In response to the Armidale BESS (SSD-23515853) *Amendment Report (July 2025)*, *consolidated response to RFIs* and updated *Addendum Traffic Impact Assessment (dated 18 July 2025)*, Council provides the following advice:

Subject: Armidale Battery Energy Storage System

SSD-23515853, Armidale Battery Energy Storage System; Response to addendum Traffic Impact Assessment, Request for further information

SSD-23515853, Armidale Battery Energy Storage System; Response to addendum Traffic Impact Assessment, Request for further information

Figure 1: Pinch Point – OSOM vehicle traversing over median island at Jerry Plains Road off-ramp and Putty Road. Source: Drawing No. EMM-009 – Armidale Battery Energy Storage System OSOM assessment - Appendix A swept path assessments

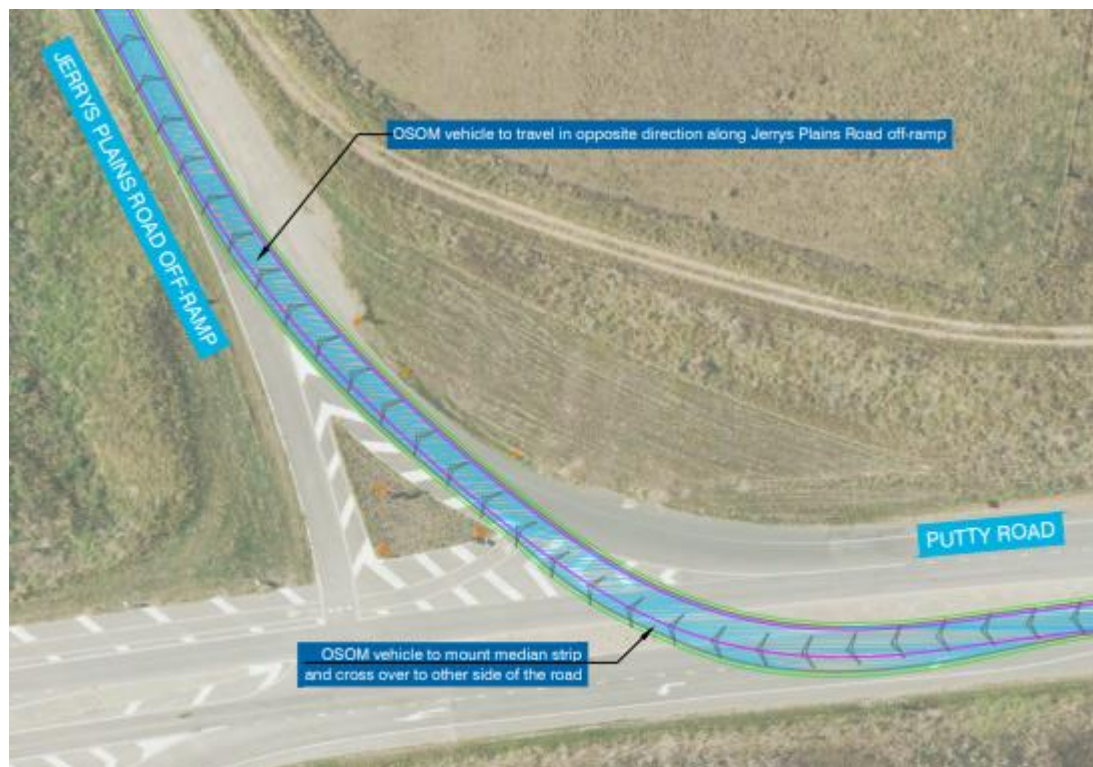
<p>3</p>	<p>Golden Highway / Denman Road. The existing kerbing is proposed to be temporarily removed. Strategic concept designs and further details are required to address the following for this pinch point:</p> <p>a) The location of the kerb and medians that are proposed to be temporarily removed,</p> <p>b) The timeframes for removal and reinstatement of the kerbs and medians,</p> <p>c) Details of what type of kerbing and medians will be reinstated after completion of the transformer high-risk OSOM movement.</p>	<p>CLOSED:</p> <p>The swept path assessment at this intersection has been updated and the right turn movement from Golden Highway onto Denman Road does not mount the kerb.</p>
<p>4</p>	<p>The New England Highway / Bell Street swept path shows that signal pedestals must be removed temporarily. Strategic concept designs and further details are required to address the following for this pinch point:</p> <p>a) The location of the proposed signal pedestals to be temporarily removed.</p> <p>b) The timeframes for the removal and reinstatement of the signal pedestals.</p> <p>c) Kerb and medians that are proposed to be temporarily removed.</p>	<p>CLOSED:</p> <p>New England Highway/Bell Street intersection will not be used as part of the high-risk OSOM routes.</p>

Figure 2: Pinch Point – OSOM vehicle traversing over median island at New England Highway/ Scott Road, Tamworth. Source: Drawing No. EMM-023 – Armidale Battery Energy Storage System OSOM assessment - Appendix A swept path assessments

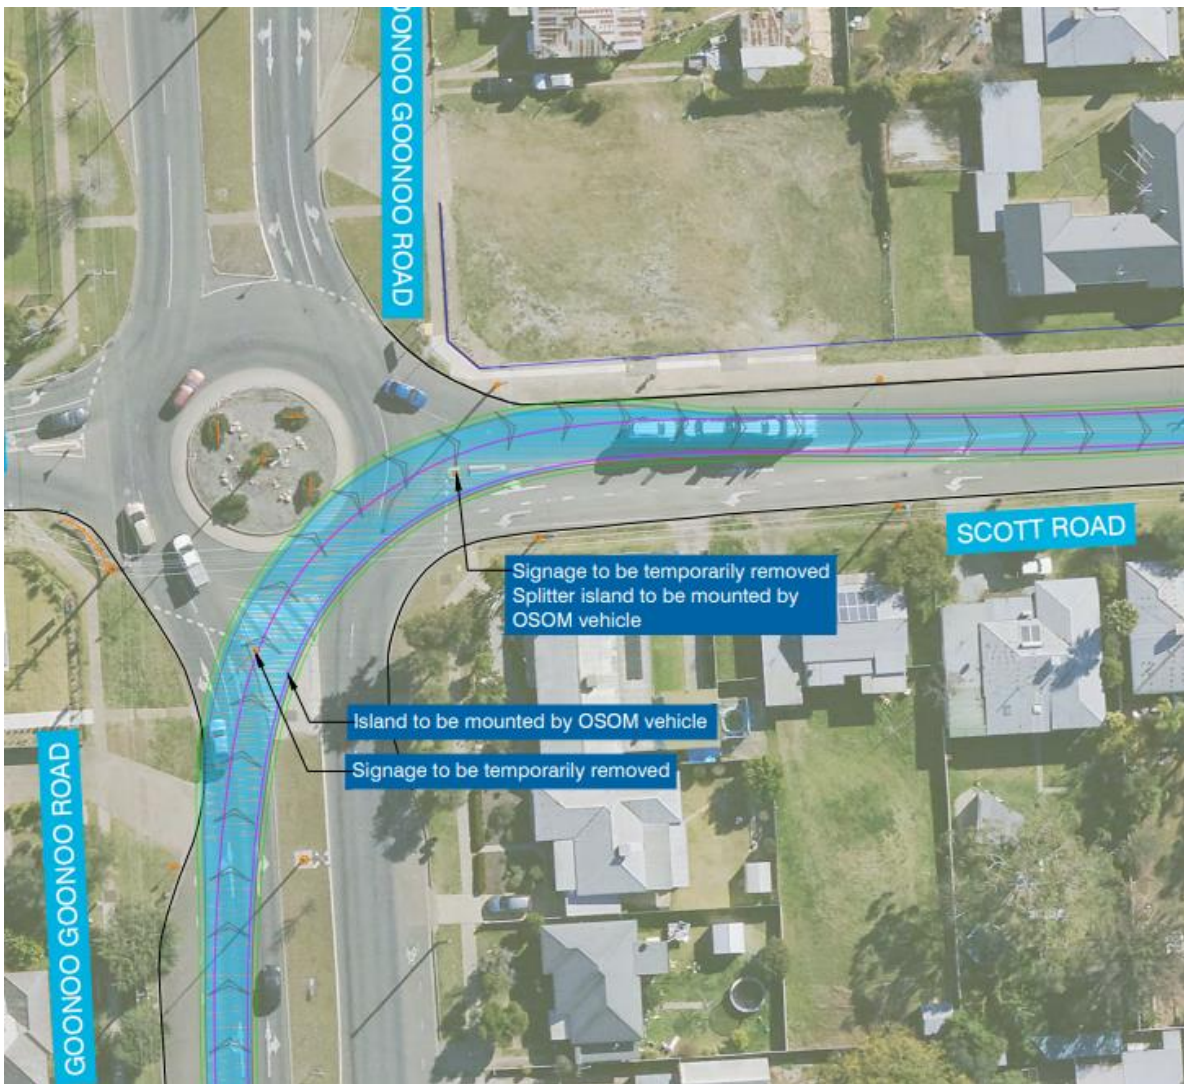
<p>6</p>	<p>Strategic concept designs are to be prepared and included within the revised TIA for the road works proposed to the centre islands of the New England Highway/Oxley Highway, which are identified within the route analysis as a requirement for the high-risk OSOM-laden vehicle configuration to navigate this pinch point</p>	<p>OPEN:</p> <p>Armidale BESS proposes to traverse median or refuge island at 6 locations on the state road network (see figures within Attachment B for locations), using a rubber mat and steel protection method to safeguard the medians. This method cannot be supported by TfNSW.</p> <p>The revised TIA is to detail the scope of the modifications to the median(s) required to ensure that the high-risk OSOM can negotiate the pinch point(s) on the state road network without damaging the state road infrastructure.</p> <p>If traversing of the medians on the state road network cannot be avoided, then strategic concept designs will be required that identify the scope of the works that would be necessary to ensure the median could be traversed and withstand the mass of the high-risk OSOM movement (i.e pavement strengthening). Strategic concept designs will need to be submitted to identify the extent of the road upgrades, or provide a strategic concept design that identifies the temporary or partial removal of the median, in accordance with Austroads and TfNSW requirements, that will allow for the high-risk OSOM to navigate through this pinch point.</p> <p>Note: Temporary removal will need to include the length of time for removal, any interim treatments (e.g., line marking), and when and what will replace the median post-completion of high-risk OSOM movement. Alternative options to avoid traversing the state road network infrastructure include changing the route or modifying the high-risk OSOM vehicle configurations.</p> <p>Note: TfNSW advises that changing the route and changing the vehicle configuration of the high-risk OSOM could potentially increase the scope of works required on the public road network.</p>

Figure 4: Pinch Point – OSOM vehicle traversing over refuge island at Kentucky Street, Armidale. Source: Drawing No. EMM-031 – Armidale Battery Energy Storage System OSOM assessment - Appendix A swept path assessments

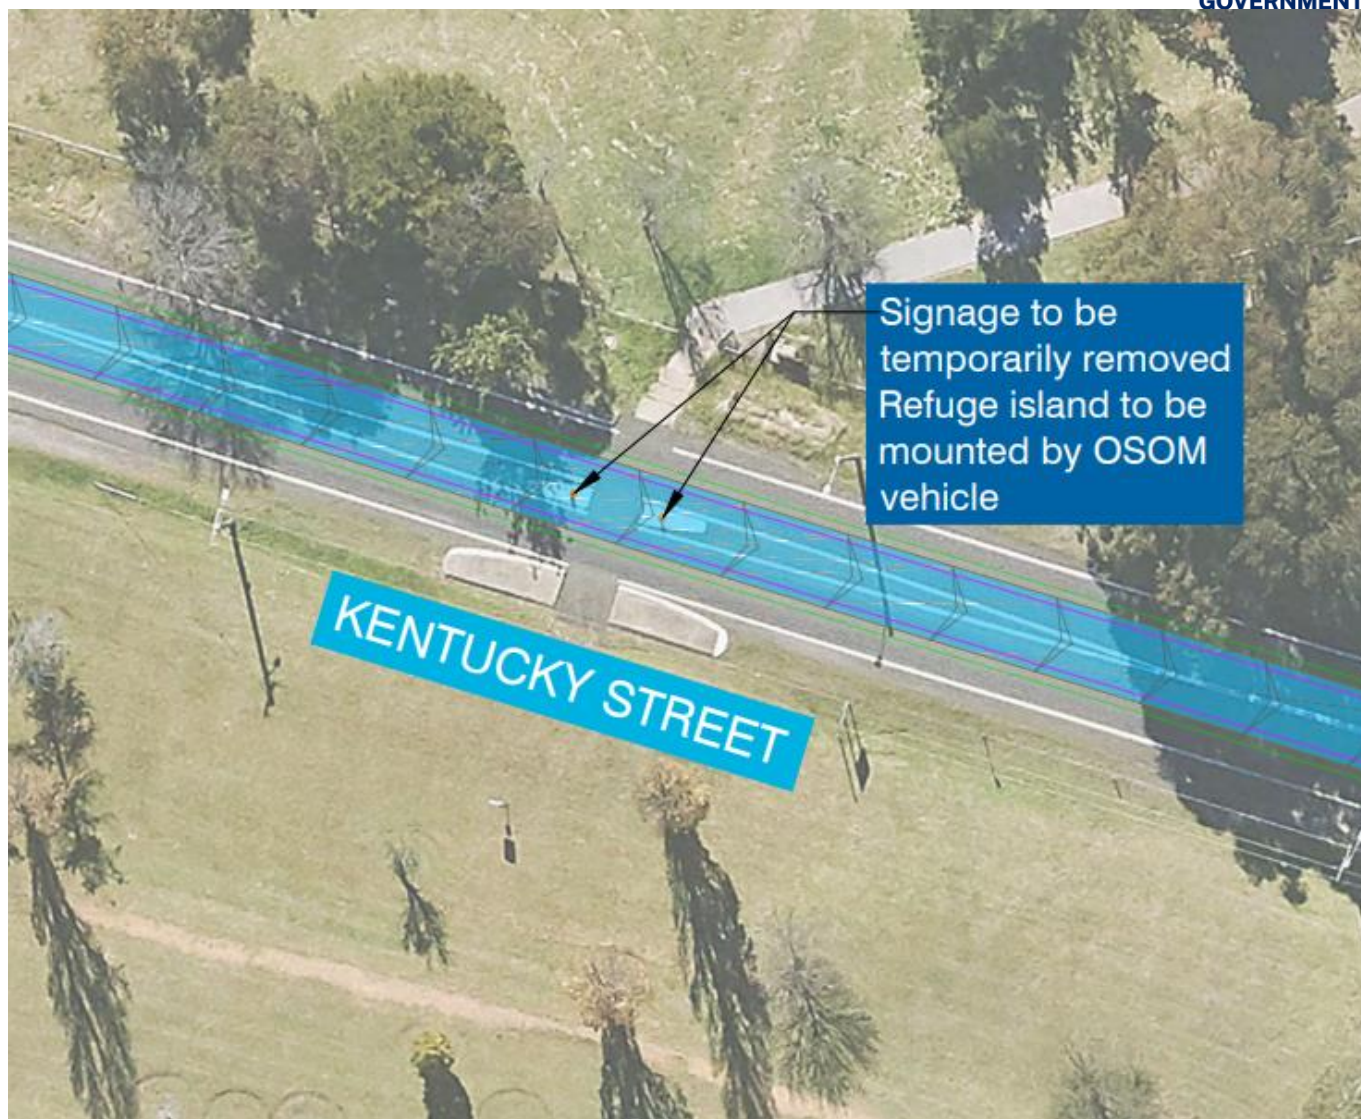
7	<p>Strategic concept designs are to be prepared and included within the revised TIA for the road works proposed to the centre islands of the Waterfall Way/ Canambe Street, which are identified within the route analysis as a requirement for the high-risk OSOM-laden vehicle configuration to navigate this pinch point.</p>	<p>CLOSED:</p> <p>The report states that hardstands required at the Waterfall Way/Canambe Street roundabout and that the design will be to TfNSW standards. The impacted kerb, grassed road reserve and footpath at that location are Council assets so it will be for Council to determine the requirements</p>
8	<p>The project proposes to use the route via Sydney Road and under the rail underpass through Muswellbrook. The rail underpass has height and horizontal geometric limitations, such as barriers and other infrastructure, that need to be reviewed to assess whether traversing underneath the rail overpass on Sydney Road would be a viable option as a high-risk OSOM route based on the project-laden height, width, and length for the high-risk OSOM-laden vehicle configuration. TfNSW notes that the route analysis has considered the alternative route via Bell Street. TfNSW requires point 7 to be addressed and confirm whether both options will continue to form part of the project's high-risk OSOM routes through Muswellbrook.</p>	<p>CLOSED:</p> <p>The high-risk OSOM route analysis no longer includes the use of Sydney Road within Muswellbrook, as part of the route.</p>
